Seabrook Station
License Amendment Request 02-04
“Revision To Technical Specifications Associated With Pressure/Temperature
Curves and Low Temperature Overpressure Protection Limits”

SEABROOK STATION UNIT 1

**License Amendment Request 02-04,
"Revision To Technical Specifications Associated With Pressure/Temperature Curves
and Low Temperature Overpressure Protection Limits"**

FIGURE 3.4-2
REACTOR COOLANT SYSTEM HEATUP LIMITATIONS - APPLICABLE UP TO 20 EFPY

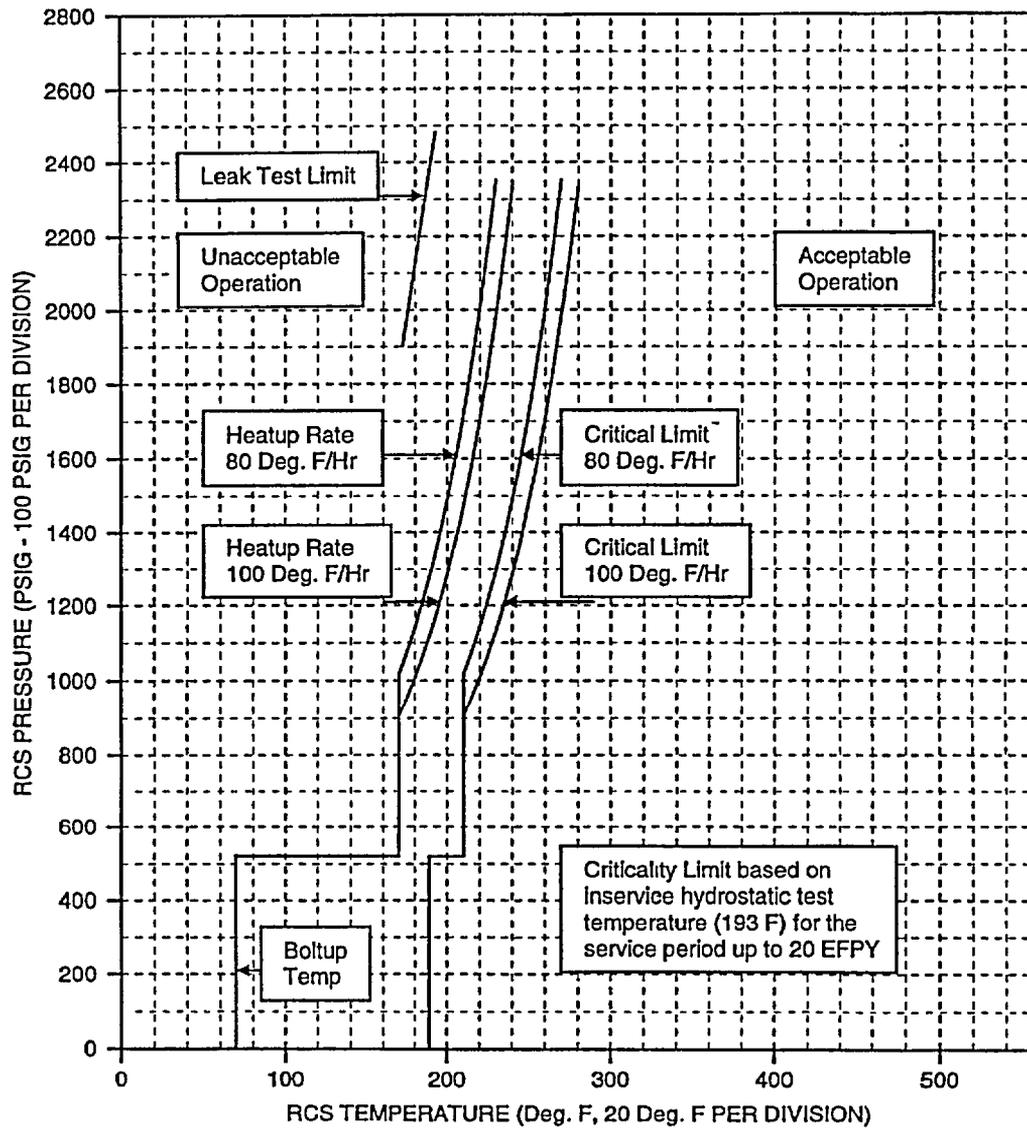
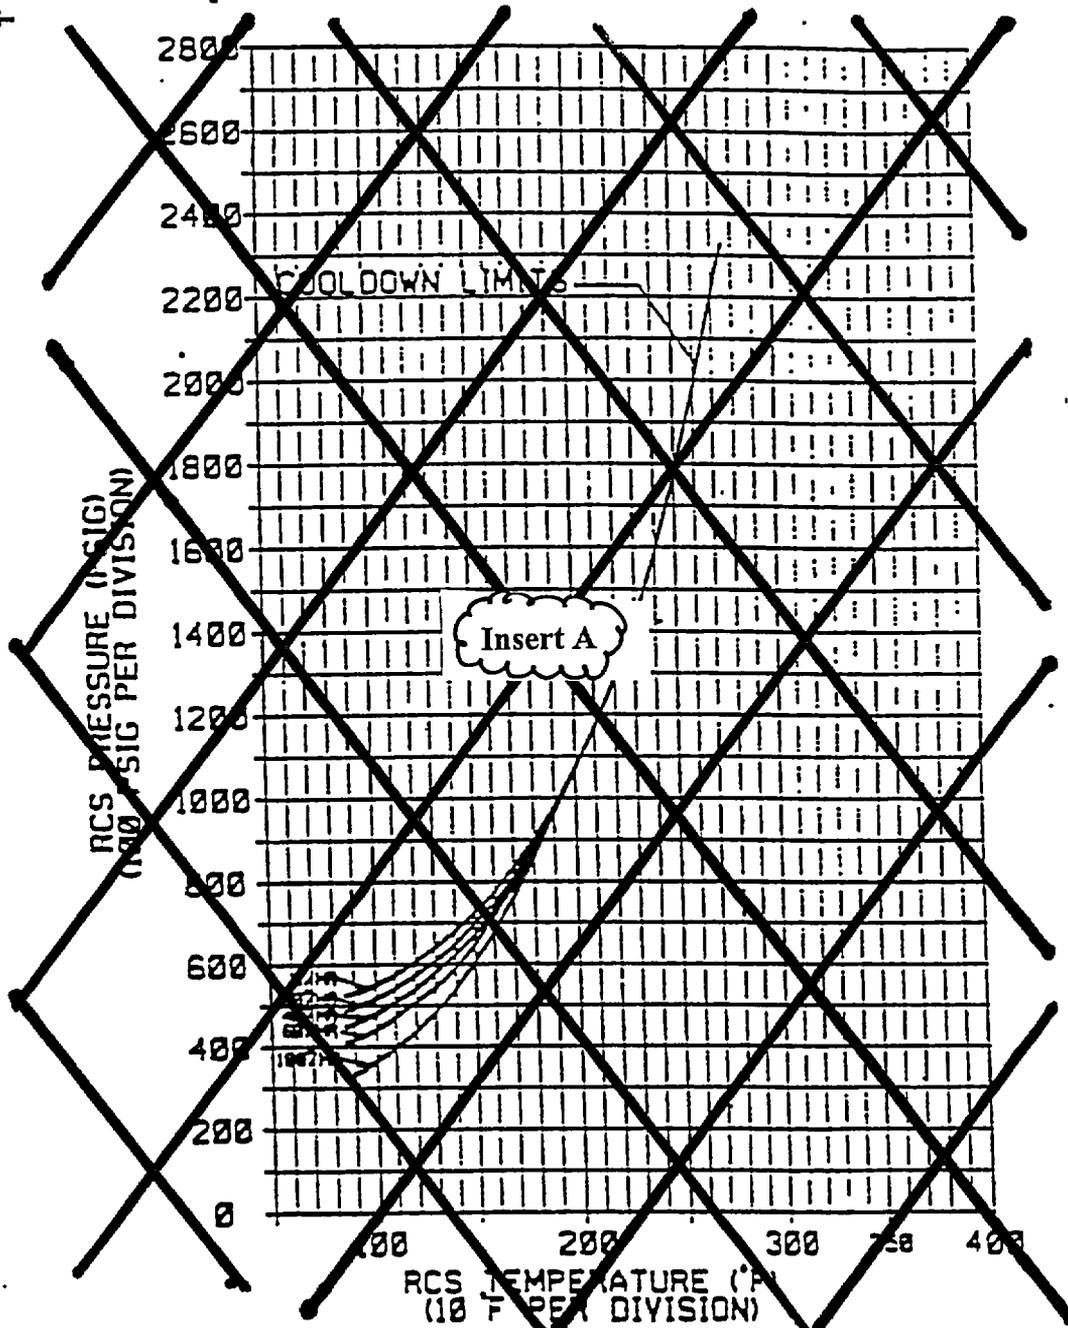
~~MATERIAL PROPERTY BASIS~~

~~Controlling material: Base metal~~
~~Copper content: 0.06 wt%~~
~~RT initial: 40°F~~
~~RT NDT after 11.1 EFPY: 1/4T, 108°F~~
~~RT NDT: 3/4T, 86°F~~

~~Curve applicable for cooldown rates up to 100°F/hr for the service period up to 11.1 EFPY and contains margins of 10°F and 60 psig for possible instrument errors~~

3/4T, 88°F

Curves applicable for the first 20 EFPY and contain margins of 20°F and 100 psig for possible instrument errors

FIGURE 3.4-3
REACTOR COOLANT SYSTEM COOLDOWN LIMITATIONS - APPLICABLE UP TO 20 EF PY

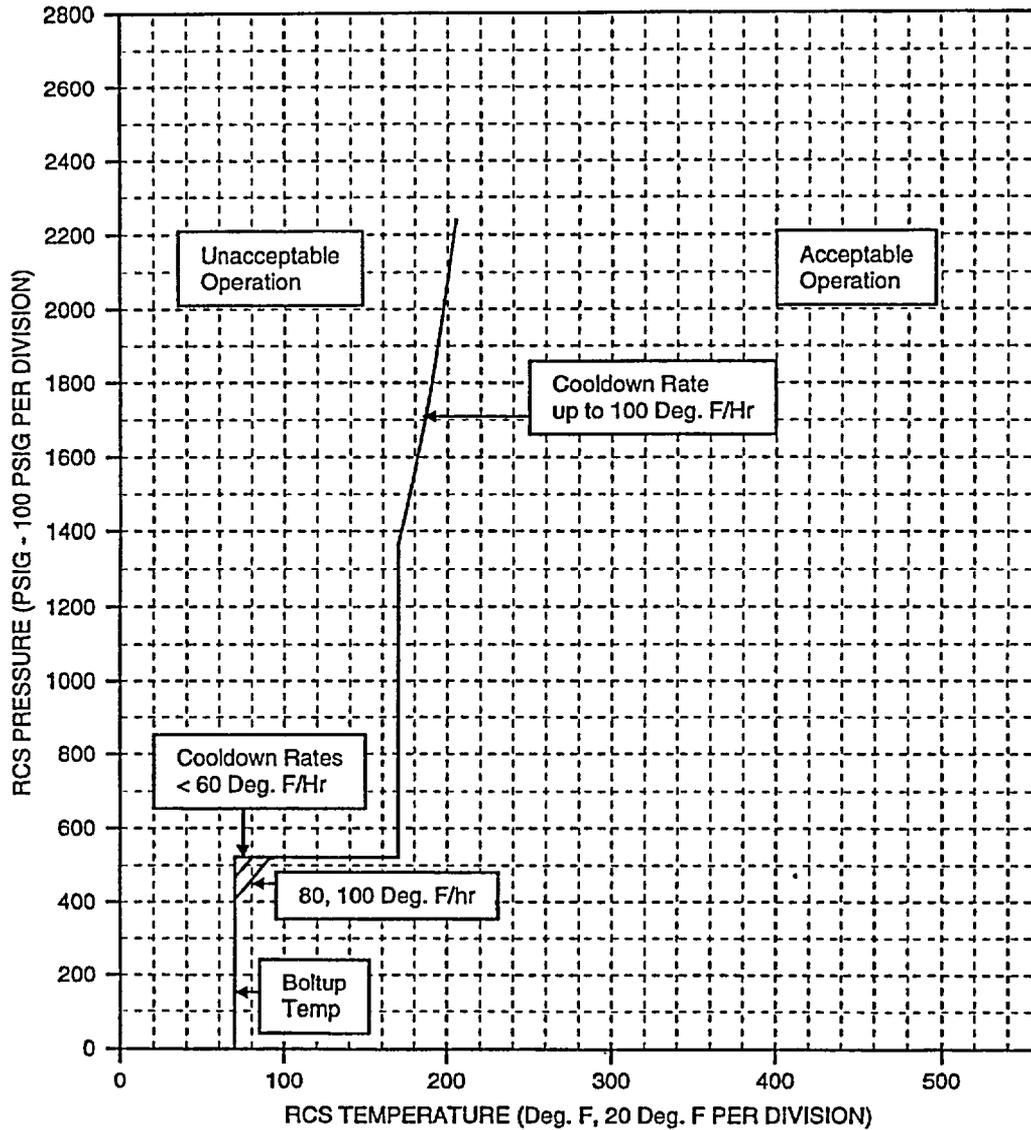
~~FIGURE 3.4-3~~

3/4T, 88°F

Curves applicable for the first 20 EF PY and contain margins of 20°F and 100 psig for possible instrument errors

FIGURE 3.4-4 RCS COLD OVERPRESSURE PROTECTION SETPOINTS

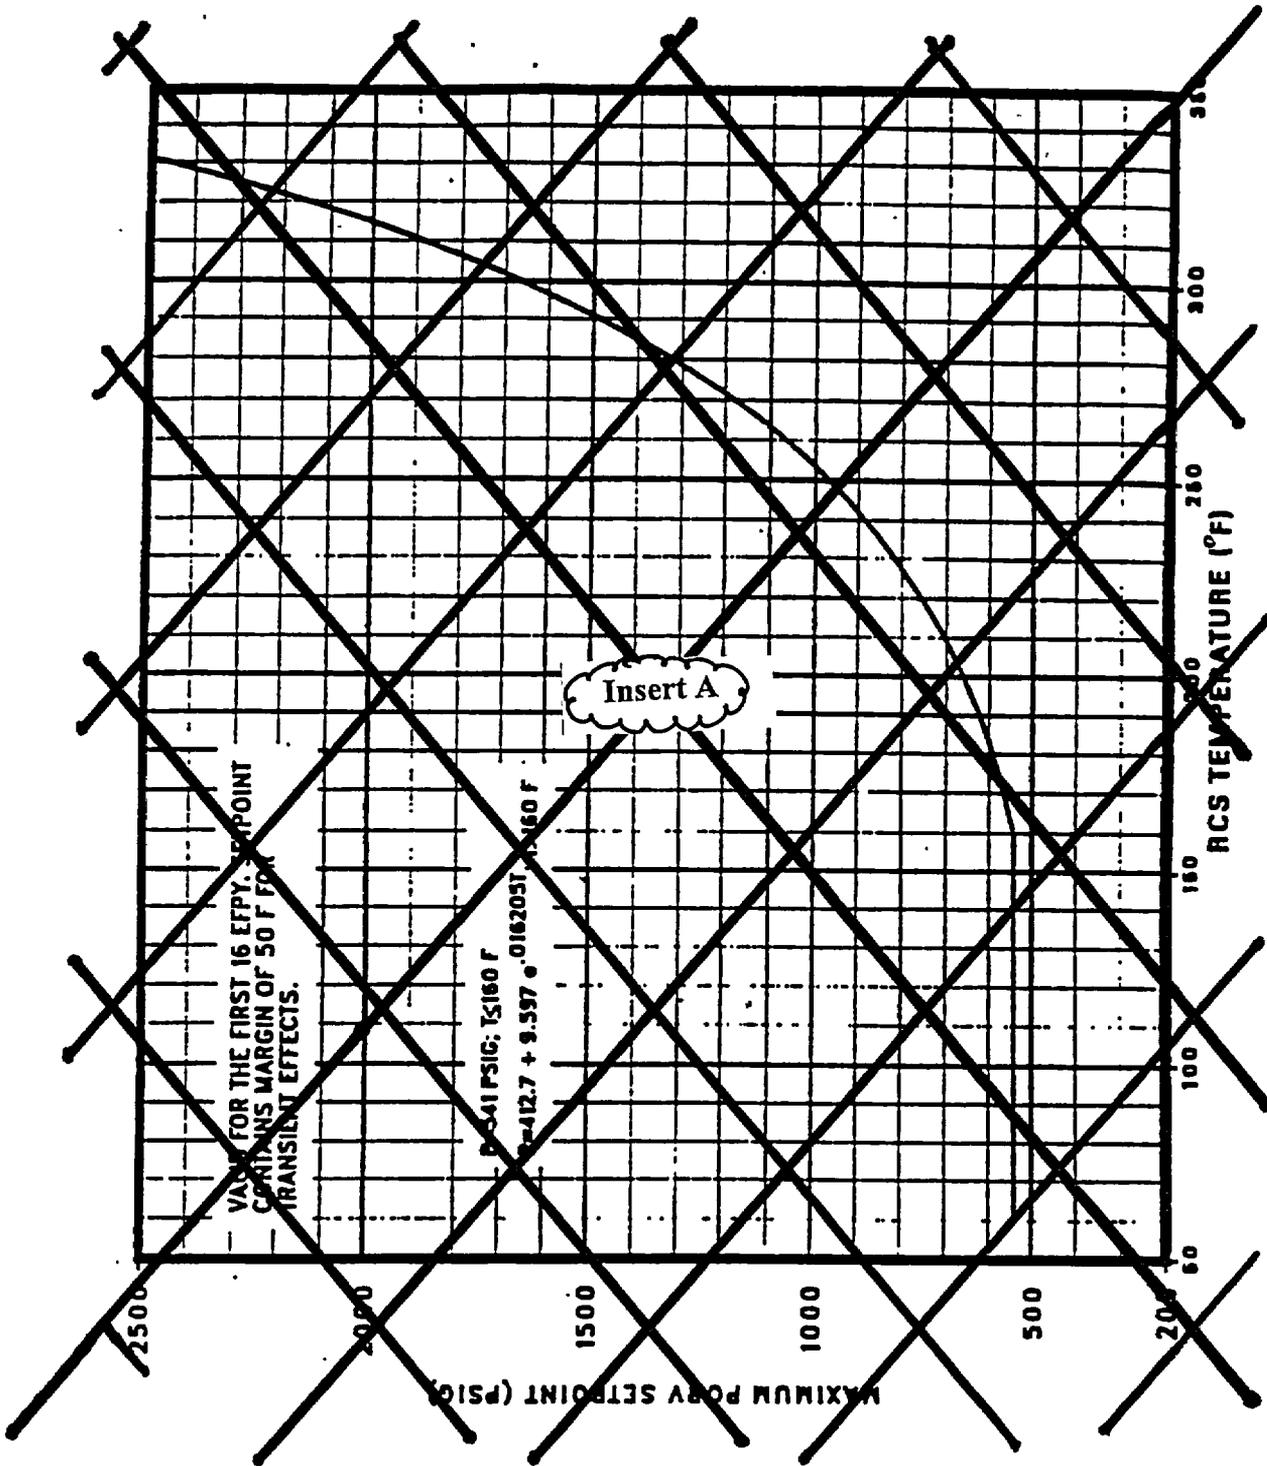
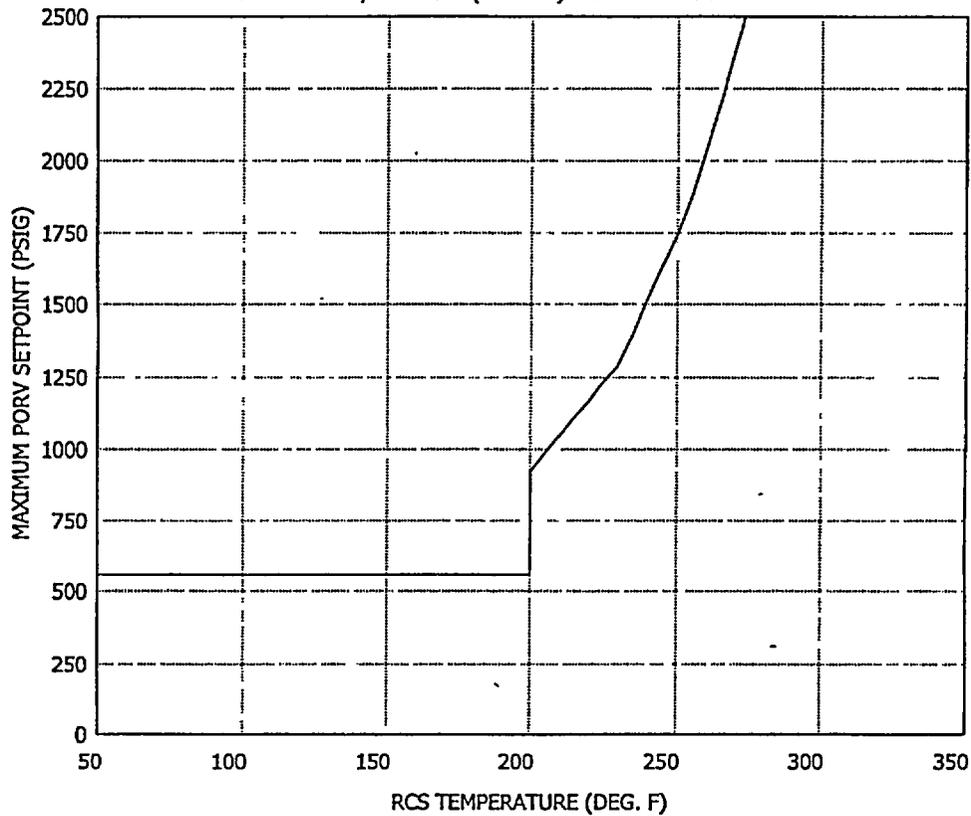
License Amendment Request (LAR) 02-04 proposes a change to Seabrook Station Technical Specification 3.4.9.3 "Reactor Coolant System – Overpressure Protection Systems". Specifically, the proposed change replaces Technical Specification Figure 3.4-4, "RCS Cold Overpressure Protection Setpoints" and revises the COPPS arming temperature. The maximum PORV COPPS setpoints specified in Figure 3.4-4 and COPPS arming temperature are revised to reflect the higher allowable low temperature overpressure protection (LTOP) pressure limit afforded by the use of ASME Code Case N-641. The revised pressurizer PORV COPPS setpoints have been derived for operation of Seabrook Station's reactor vessel to a cumulative exposure of 20 EFPY, consistent with the proposed revisions to the P/T limits in Figures 3.4-2 and 3.4-3. Credit is taken for the fact that experience shows that LTOP events are most likely to occur at isothermal conditions. The LTOP allowable pressure limit for the COPPS is therefore taken to be the steady-state (isothermal) P/T pressure limit curve. The allowable pressure is limited below 150°F, to comply with the closure head/vessel flange region limitation on system pressure imposed by 10 CFR Part 50, Appendix G. The revised COPPS setpoints provide overpressure protection for the Seabrook reactor vessel and closure head/flange region in accordance with ASME Code Case N-641 and 10 CFR Part 50 Appendix G.

FIGURE 3-4-4 RCS COLD-OVERPRESSURE-PROTECTION-SETPOINTS

$$230.5^{\circ}\text{F} < T \leq 255.0^{\circ}\text{F}, P = 23.15*(T-230.5) + 1295.05 \text{ PSIG};$$

$$T > 255.0^{\circ}\text{F}, P = 34.5*(T-255.0) + 1862.225 \text{ PSIG}$$
